Access Compliance Report Public Rights-of-Way (Pedestrian Signals)

Main Street: **ESENCIA_DR** Cross Street: **COW_CAMP_RD** Location: **E**

ADA ID: **SGRK211129121527** Signal Type: **One Push Button-Non APS** Overall Compliance: **No** Severity Scores: **BTN 1: 25** **BTN 2: N/A** **No BTN: N/A**

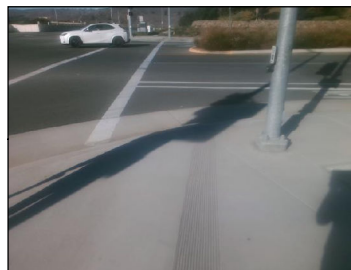
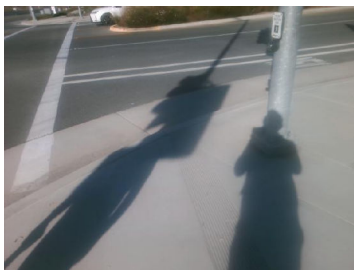
OC Std/PROW: MUTCD 4e.08, R404.2, R404.3

Possible Solutions: Replace Signal Push Button With APS Button. Remove & Relocate Sign.
